UNITED STATES PATENT AND TRADEMARK OFFICE

APPLICATION NO.	FILING DATE	FIRST NAMED INVENTOR	ATTORNEY DOCKET NO.	CONFIRMATION NO.
10/601,701	06/24/2003	Ching-Fa Yeh	BHT-3230-56	7550

Office Action Summary

DETAILED ACTION

FIG. 1

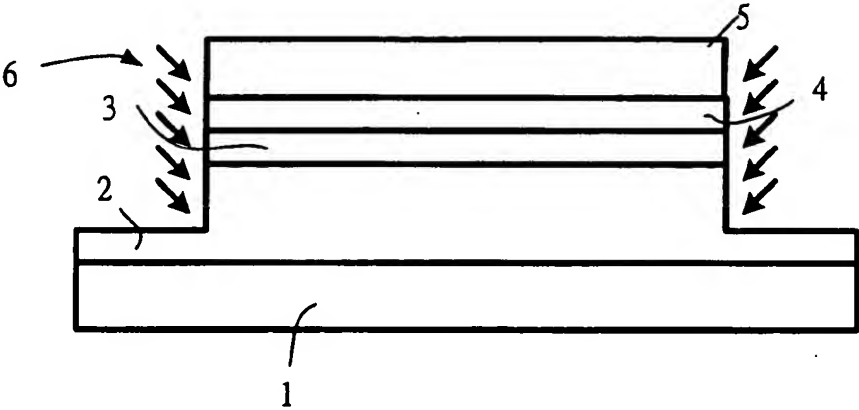
The drawings are objected to under 37 CFR 1.83(a). The drawings must show every feature of the invention specified in the claims. Therefore, the active layer must be shown, specifically in figures 1-3 or the feature(s) canceled from the claim(s). No new matter should be entered.

35 U.S.C. 112, first paragraph, requires the specification to be written in "full, clear, concise, and exact terms." The specification is replete with terms which are not clear, concise and exact. The specification should be revised carefully in order to comply with 35 U.S.C. 112, first paragraph. Examples of some unclear, inexact or verbose terms used in the specification are: For example, on page 4, lines 22-24, "d) process, a thermal insulating layer of laser annealing or a hard mask of the removal pf polysilicon spacer after recrystallization;" is unclear in its meaning. In addition, on page 4, lines 25-28, "using a solution of silicon dioxide 6 of wet isotropic etching..." How is this possible? Especially since conventionally wet etching techniques may be used to etch silicon dioxide. Finally, on pages 5-6, lines 10-11, 21-22 and 1-3, respectively, "the polysilicon spacer 7" is disclosed as being "behind either side of the active layer", "under either side of the active layer" and "to be surrounded the side of active layer" it is unclear what is the meaning with regards to the location of the "polysilicon spacer 7". According the disclosed figures 1-3, it appears that the "polysilicon spacer 7" is on either side of

"the amorphous silicon layer 3", however, it is unclear what direction exactly where is the active layer, etc. Clarification is requested.

Enclosed are new formal drawings of Figures 1-7, accompanied by a LETTER TO THE OFFICIAL DRAFTSPERSON. Figure 1 was amended to correct the reference line for reference number "6", and the words "Wet Etching" were deleted.. Figure 2 was amended to properly identify reference line with reference numbers "1", "2", "3", "3a", "4", "7", and "8", and the words "Dry Etching" were deleted. Figure 3 was amended to add reference number "15", and the words "Excimer Laser Recrystallization" and "Direction of Grain Growth" were deleted. Figure 4 was amended to replace the words with reference numbers --7--, --10--, --11--, and --12--. Figure 5 was amended to replace the words with reference number --7--. Figure 6 was amended to replace the words with reference numbers --7--, --13--, and --14--. Figure 7 was amended to replace the words with reference numbers --7--, --10--, --11--, and --12--, and add the label --Prior Art--.
